# ELECTRICAL MECHANICAL PLAN BUILDING B

NEW ELEMENTARY SCHOOL
9801 HIGHLAND KNOLLS DR
BAKERSFIELD
CALIFORNIA
93306

NEW MIDDLE SCHOOL
4115 VINELAND ROAD
BAKERSFIELD
CALIFORNIA
93306

SHEET IDENTIFICATION NUMBER
E-122B

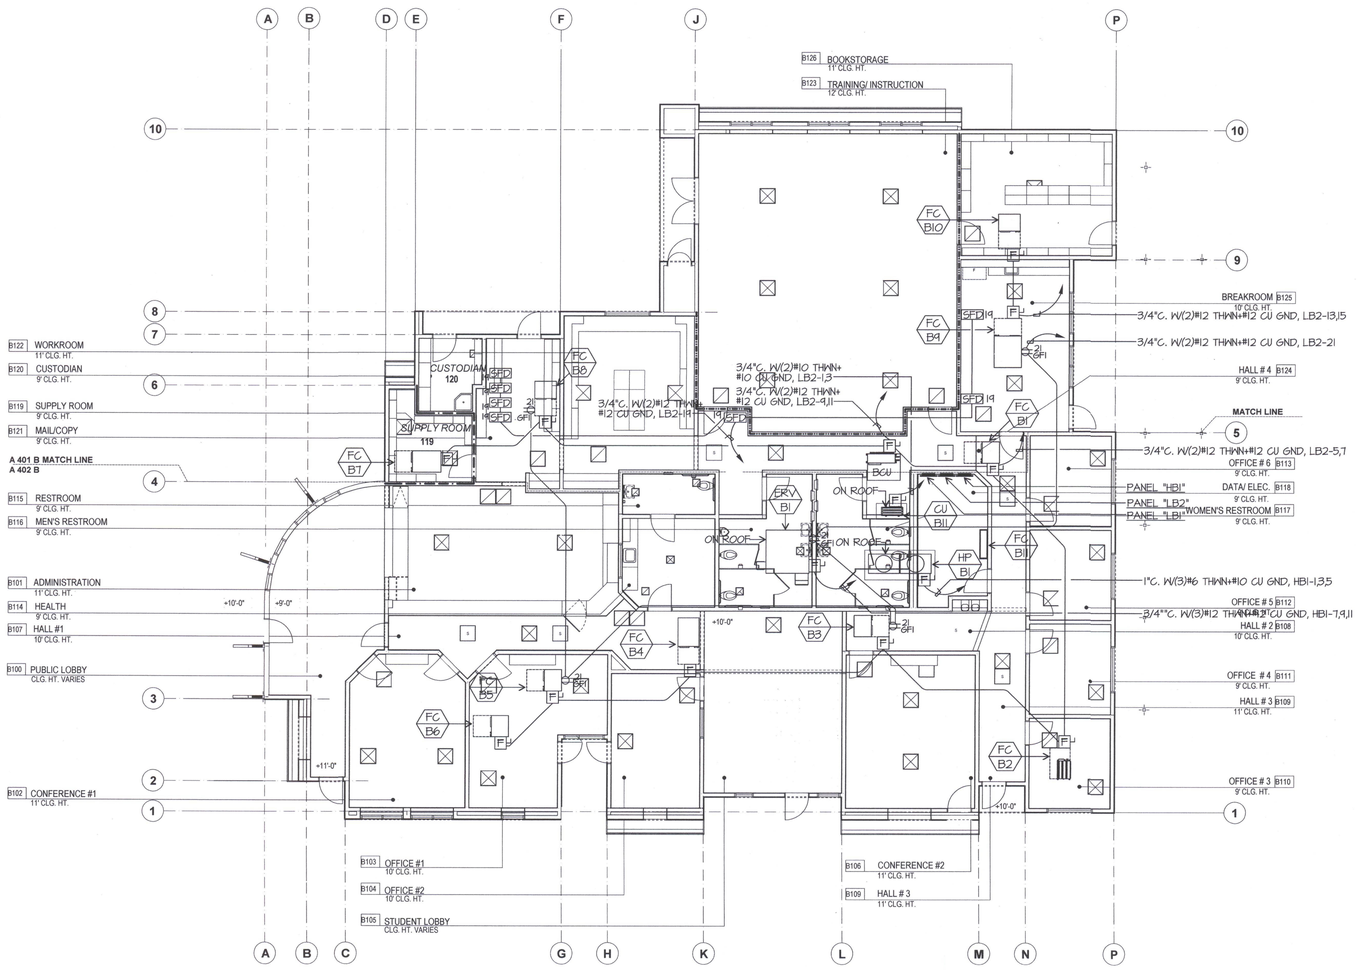
Reference Sheets E-122B, E122C, E122D, E122E, E122F, E122G, E122N, E122P & Approved HVAC Submittals
Per the approved HVAC submittals, Heat Pumps B1, C1, C2, D1, D2, E1, E2, F1, F2, G1, G2, N1, N2, N3, N4, P1 and P3 consist of two modules which each require separate electrical connections and different max fuse sizes. Per the Electrical Plans for Buildings B, C, D, E, F, G, N and P, there is only one disconnect switch and one 480V, 3PH feed shown for each unit. Do these multiple module heat pump units require an additional disconnect and feed due to the fact that they require different max fuse sizes? Please advise.

The Electrical Plan for Building B shows (1) Type EC Light fixture to be installed in the exterior soffit outside of Room B105. The Architectural Plan for Building B does not show a light fixture to be installed in this same location. Does a Type EC light fixture need to be installed in this location? Please advise.

Reference Sheet A234B & E-131B
Per the Electrical Plans for Building B, there is a Fire Alarm speaker strobe to be installed on the south wall of Room B114. However, per the Architectural Plans for Building B, there is a wall cabinet to be installed on the south wall that prevents the speaker strobe from being installed at the location shown. Is it acceptable to move this device to the east wall? Please advise.

See attached equipment schedule on Sheet M-502 and detail M-M-504.

Yes.

**ANSWER:**
LOCATE TO NEXT WALL AS INDICATED.
JHE/OMA 11/30/12
